STATE OF CONNECTICUT
CONNECTICUT SITING COUNCIL

IN RE: :
 :
APPLICATION OF CELLCO : DOCKET NO. 469
PARTNERSHIP D/B/A VERIZON :
WIRELESS FOR A CERTIFICATE OF :
ENVIRONMENTAL COMPATIBILITY AND :
PUBLIC NEED FOR THE CONSTRUCTION, :
MAINTENANCE AND OPERATION OF A :
WIRELESS TELECOMMUNICATIONS :
FACILITY AT 520 BAILEY HILL ROAD IN :
KILLINGLY, CONNECTICUT : SEPTEMBER 21, 2016

**RESPONSES OF CELLCO PARTNERSHIP D/B/A VERIZON WIRELESS
TO CONNECTICUT SITING COUNCIL PRE-HEARING QUESTIONS, SET ONE**

ATTACHMENT 3

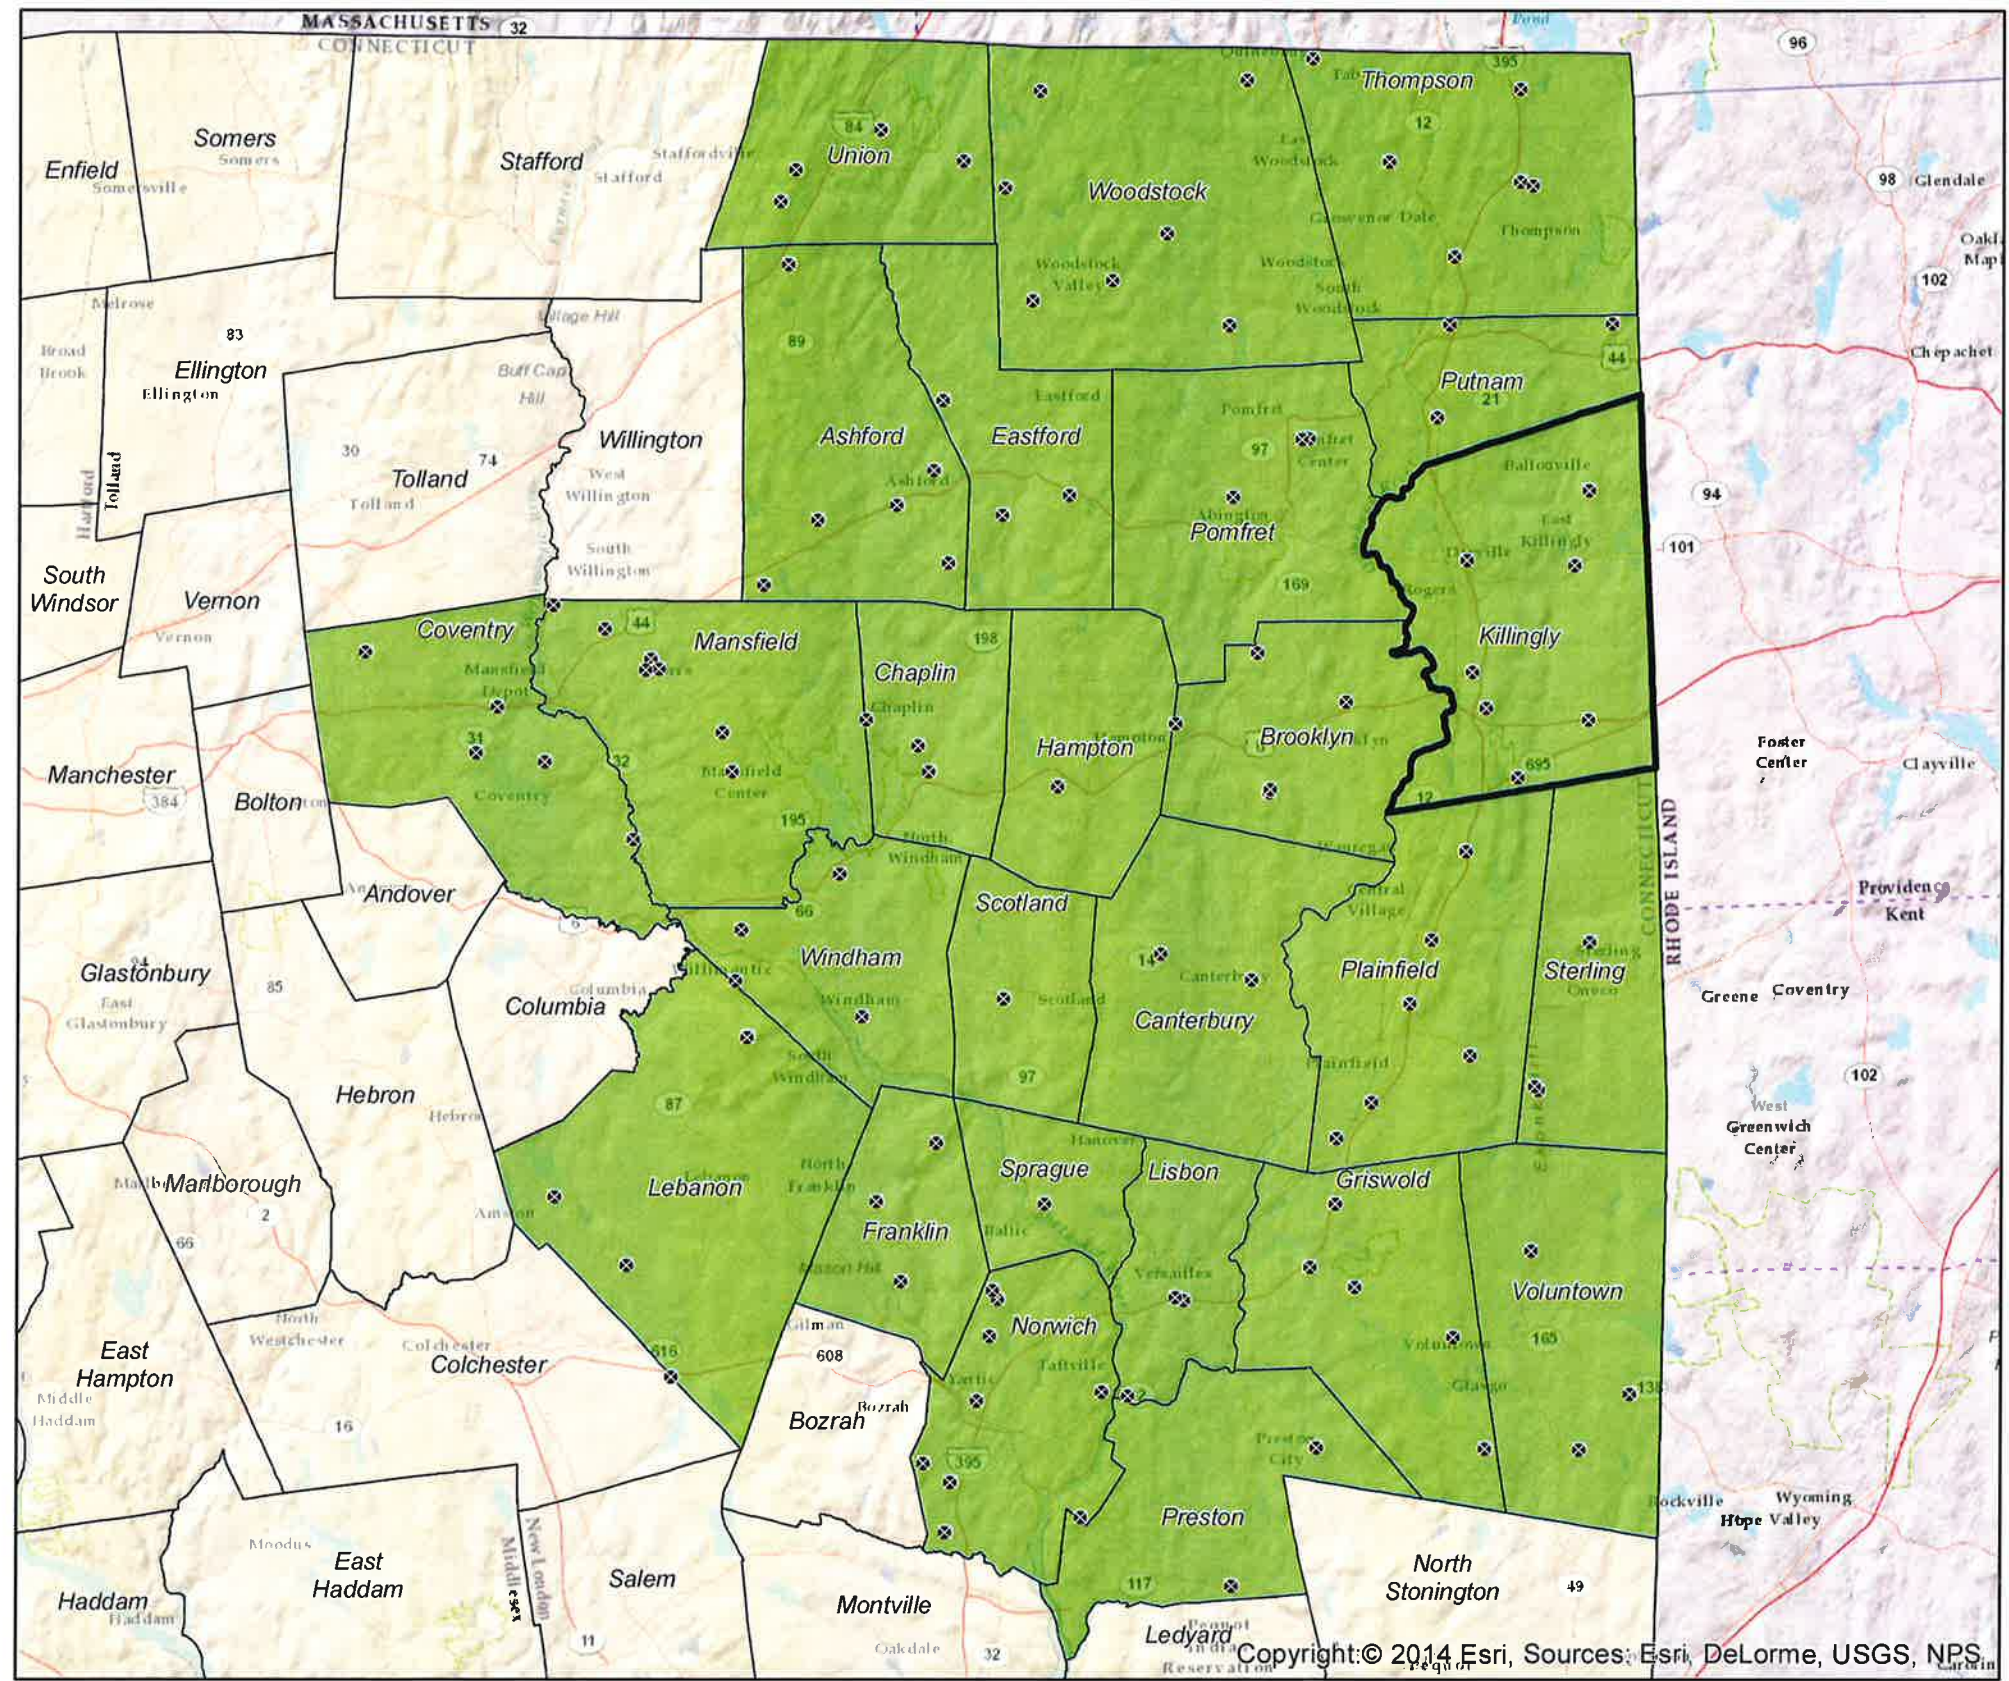
Similar to the proposed propagation maps, submit propagation maps for all four frequency bands (i.e. 700 MHz, 850 MHz, 1900 MHz, and 2100 MHz) assuming that the tower

is ten feet shorter than proposed (i.e. antennas are installed at a centerline height of 140 feet above ground level).

The propagation maps requested are included in Attachment 2.

**Existing Towers Within
The Last Green Valley, CT**

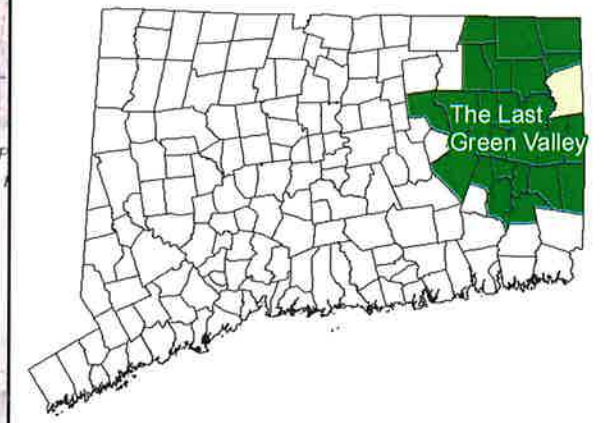
Is the proposed project located within The Last Green Valley National Heritage Area? If

yes, how would the proposed project impact The Last Green Valley National Heritage Area?

According to the Siting Council's telecommunications databases, there are at least 100 towers located in these 26 Connecticut municipalities within the NHA, including towers used by emergency service providers, radio and television broadcasts, private dispatch, and wireless telecommunications. In the Town of Killingly there are at least five existing

facilities of this nature. (See Attachment 3).
